# PERMIT

SEWAGE DISPOSAL SYSTEM

MARYLAND STATE DEPARTMENT OF HEALTH

SUBDIVISION 7249 ROAD Mink Hollow Road LOT 854-0366

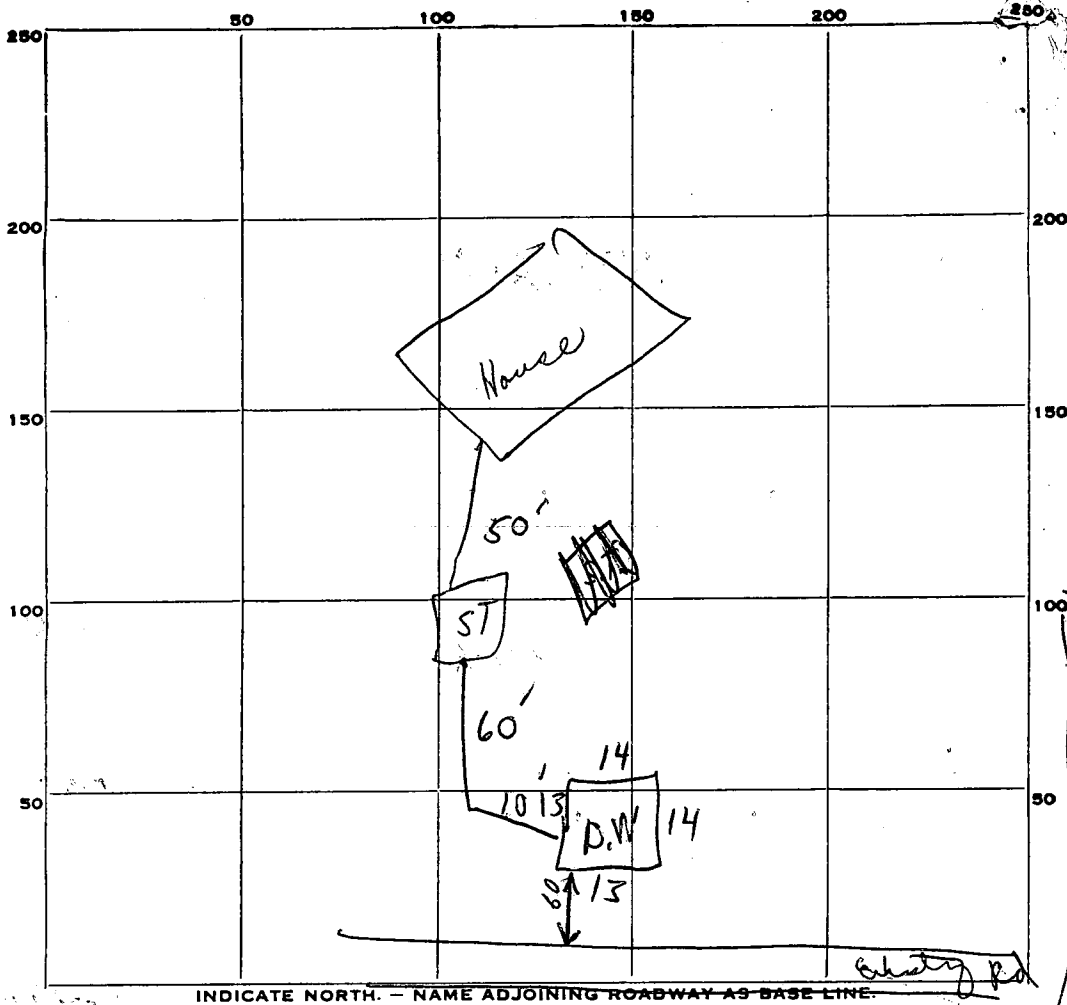
OTHER DRY WELL - 108 sq. ft. per bedroom. Inlet to be 3 1/2 ft. and maximum depth 12 ft. unless water encountered. Locate dry well about 380 ft. from edge of road and 60 ft. from the edge of Cox right of way side line as seen when standing on Mink Hollow Road.

NOTE: ALL PIPE FROM HOUSE TO DRY WELL MUST BE CAST IRON. all cast iron  
PERMIT VOID AFTER THREE YEARS.

NOTE: INSTALL STAND PIPE ON SEPTIC TANK AND DRY WELL.

PERMIT CARD Partial signed Cap needed on S.T. P.W. OK

REMARKS 5/16/73 Inspection - more gravel needed around drywell top + cement plug needed on Septic Tank.  
Cap on + gravel in D. Well Final
